# UNITED STATES PATENT AND TRADEMARK OFFICE

APPLICATION NO.	FILING DATE	FIRST NAMED INVENTOR	ATTORNEY DOCKET NO.	CONFIRMATION NO.
09/839,001	04/20/2001	Harald Apfelthaler	KWO-17702/01	2739
7590	08/26/2004		EXAMINER	
Gifford, Krass, Groh, Sprinkle, Anderson & Citkowski, P.C. Suite 400 280 N. Old Woodward Avenue Birmingham, MI 48009-5394			HORTON, YVONNE MICHELE	
			ART UNIT	PAPER NUMBER
			3635	
DATE MAILED: 08/26/2004

<b>Office Action Summary</b>	<b>Application No.</b>	<b>Applicant(s)</b>	
	09/839,001	APFELTHALER, HARALD	
	<b>Examiner</b>	<b>Art Unit</b>	<i>MW</i>
	Yvonne M. Horton	3635

**DETAILED ACTION**

FIG. 3.

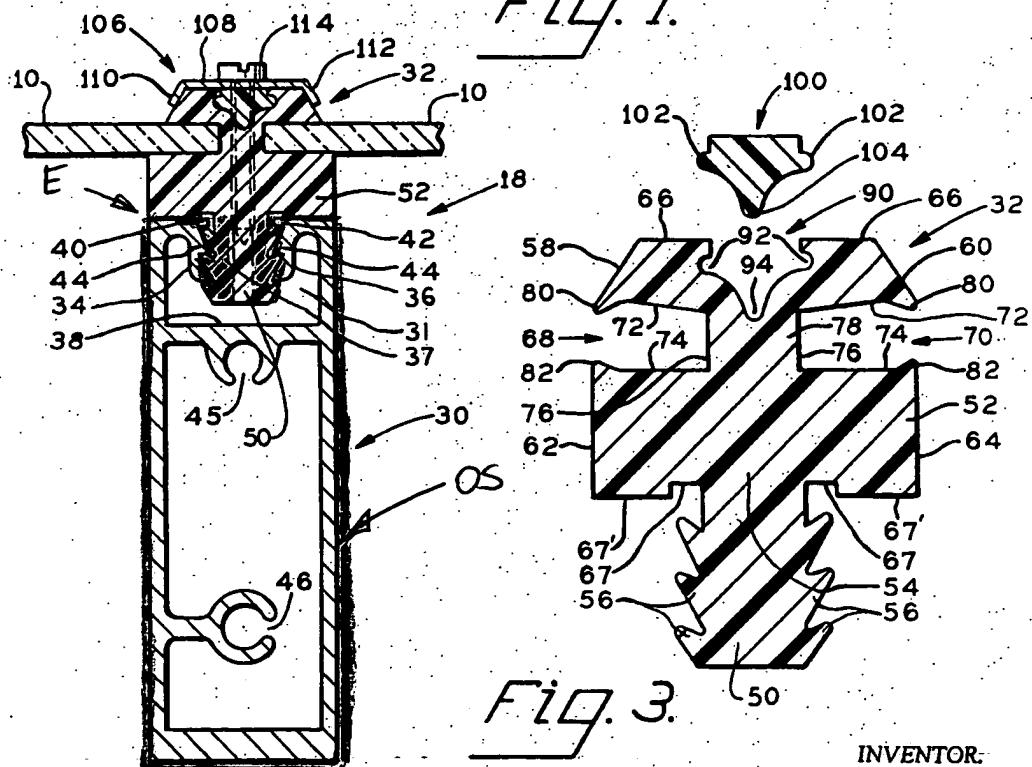
Claims 3,4 and 20 are rejected under 35 U.S.C. 102(b) as being anticipated by US Patent #3,766,698 to DALLEN. DALLEN discloses the use of a plug (32) in combination with a muntin (30) having an outer surface (OS, colored blue), an end (E), inner walls (IS) having a planar surface (40,42) that define a hollow space (colored red), see the marked attachment, and flanges (67') including a plurality of spring elements (56) such that the spring elements (56) are operable to engage the planar surface (40,42), see figures 2 and 4, and the body (50) also includes a longitudinal slot (134), column 6, line 33-39 and column 7, line 20-30, that fits into the hollow space (colored red) of the muntin (30) wherein the plug body (50), upon insertion of a screw (114) into the longitudinal slot (134), is operable by “forcing the body (50)”, column 6, lines 33-39, into the muntin (30). Due to the fact that the body (50) has a longitudinal slot (134) the body is split into two segments (colored orange) wherein upon insertion of the screw (114), the two segments (colored orange) are forced apart from one another, and into engagement with portions (34,36) of the muntin (30). In reference to claims 3 and 4, the slot (134) is coaxially aligned with the plug body (50) and completely penetrates the plug body (50), see Figure 4.

Claims 7,8 and 10 are rejected under 35 U.S.C. 103(a) as being unpatentable over US Patent #3,766,698 to DALLEN. DALLEN discloses the basic claimed muntin and terminal plug combination except for the use of the longitudinal slot having a slotted wall or teeth. Although DALLEN does not teach the use of a longitudinal slot having a slotted wall or teeth, it would have been obvious to one having ordinary skill in the art at the time the invention was made to provide the longitudinal slot of DALLEN with slots or teeth, in order to increase the tension between the plug body and the screw thereby increasing the friction therebetween to resist separation thereof and securely fasten the two members together. In regards to claim 10, obviously, if the slot (134) of DALLEN where provided with the commonly known slots or teeth of the art, the screw too includes teeth or threads having "tips" that would engage the slots or teeth formed in the longitudinal slot to enforce "widening" of the slot (134).
